PLANNING DIVISION STAFF REPORT

December 17, 2018

Project Address: 222 N. Charter Street (District 8 – Ald. Wood)
Application Type: Planned Development Zoning Map Amendment, Demolition, & Official Map Amendment
Legistar File ID #s: [53608](#), [53276](#) and [53617](#)
Prepared By: Chris Wells, Planning Division
Report Includes Comments from other City Agencies, as noted
Reviewed By: Kevin Firchow, AICP, Principal Planner
Heather Stouder, AICP, Planning Division Director

COMPARISON OF PROPOSAL TO THE SETBACKS AND STEPBACKS RECOMMENDED IN THE REGENT STREET SOUTH CAMPUS NEIGHBORHOOD PLAN

Image 1: Floor Plans (Areas Inconsistent with Plan are Shaded)

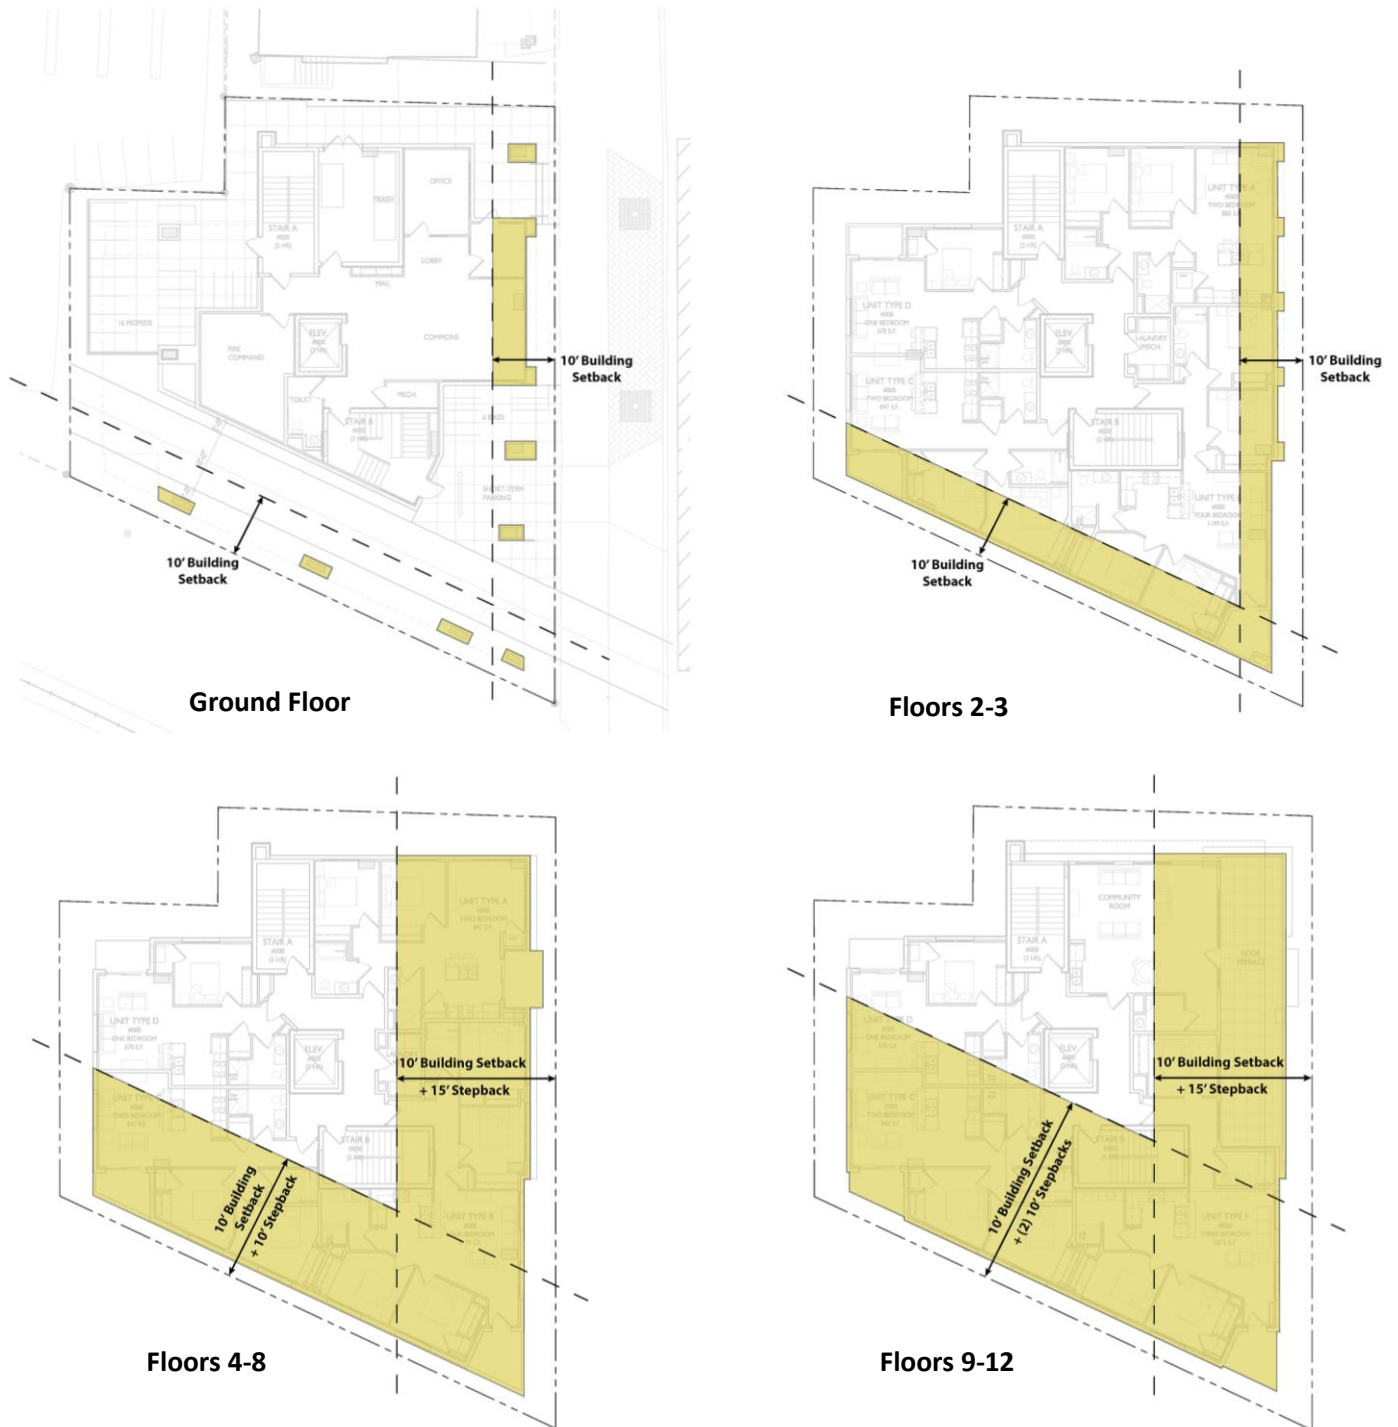
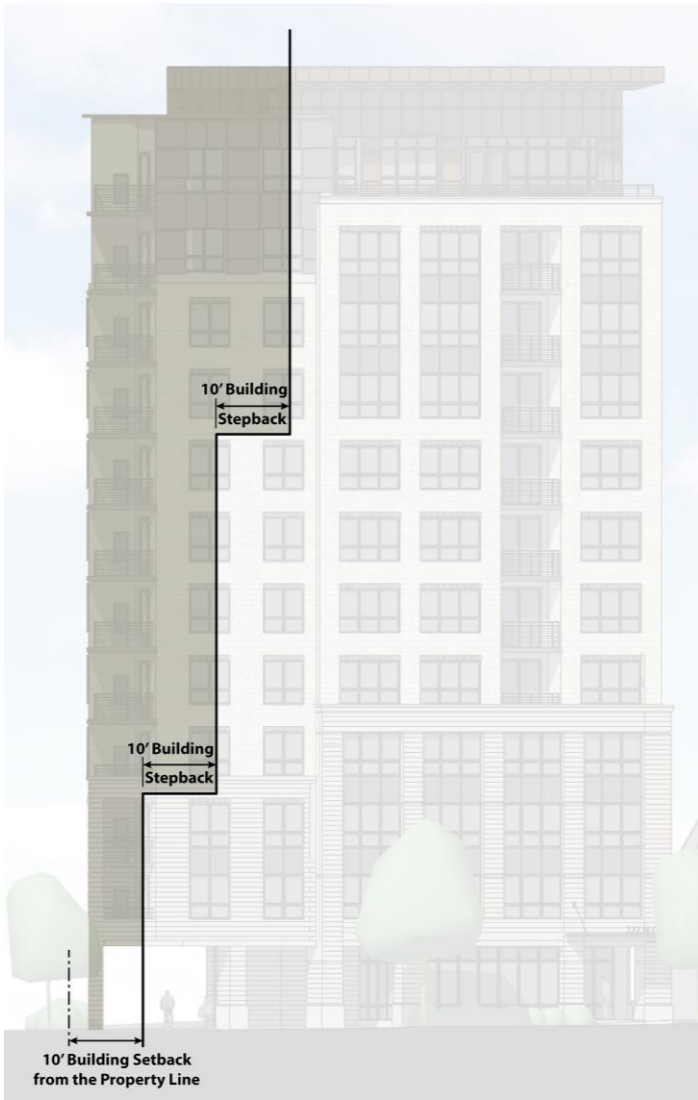
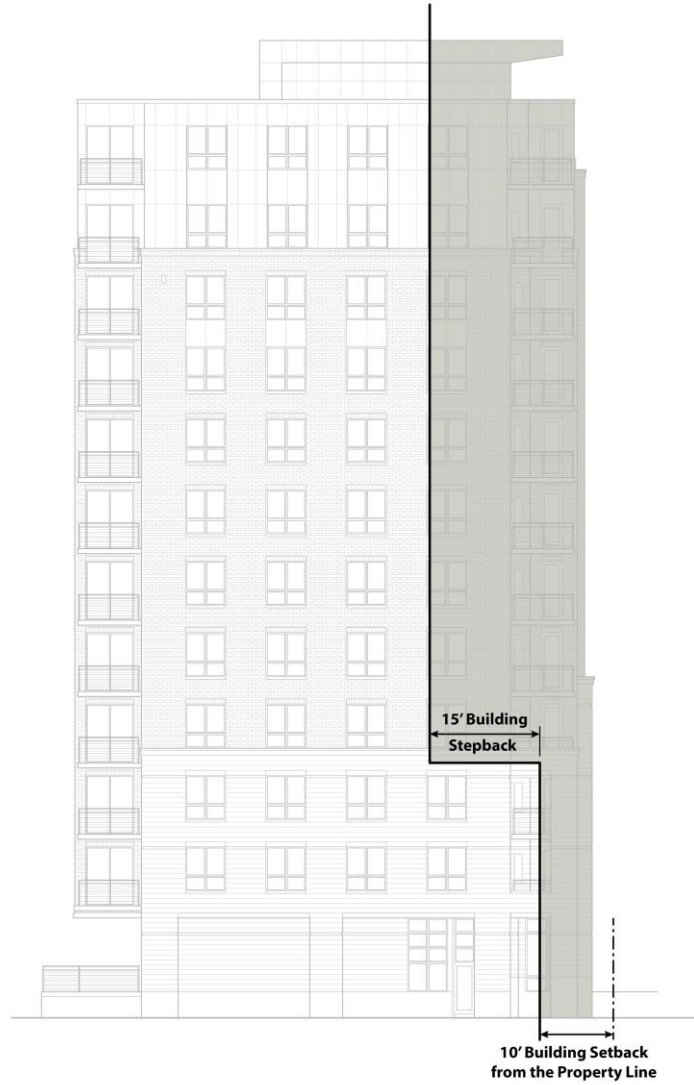
However, the project remains inconsistent with several detailed setback and stepback recommendations in the plan. In total, approximately 27,500 of the roughly 51,000 square feet of proposed above-ground building floor area or roughly 53 percent of the building, is located within the recommended setback and stepback areas. Please See **Attachment 1** at the end of this report for a graphic comparing this proposal to these recommendations.

Along Charter Street, the plan recommends a 10-foot street setback with additional 15-foot stepback above the third floor. As proposed, only some portions of the Charter Street ground floor façade comply with the recommended setback. This includes the main entrance and covered arcade features as shown in the submitted plans. The rest of the ground floor façade is set back just three feet. For the upper stories, the setback is 3-4 feet for Floors 2-3 and 4-5 feet for Floors 4-12.

Along the adjacent rail line, the plan recommends a minimum 10-foot building setback. A ten-foot stepback is called for above the third floor with an additional 10-foot stepback above the eighth story. The Plan also recommends that parking facilities should be set back at least 10 feet from the property line. While the majority of southerly ground floor façade sits roughly 18.5 feet back from the property line, columns to support the upper floors are set back 2.5 feet. The upper floors along this elevation sit 2.5 feet back.
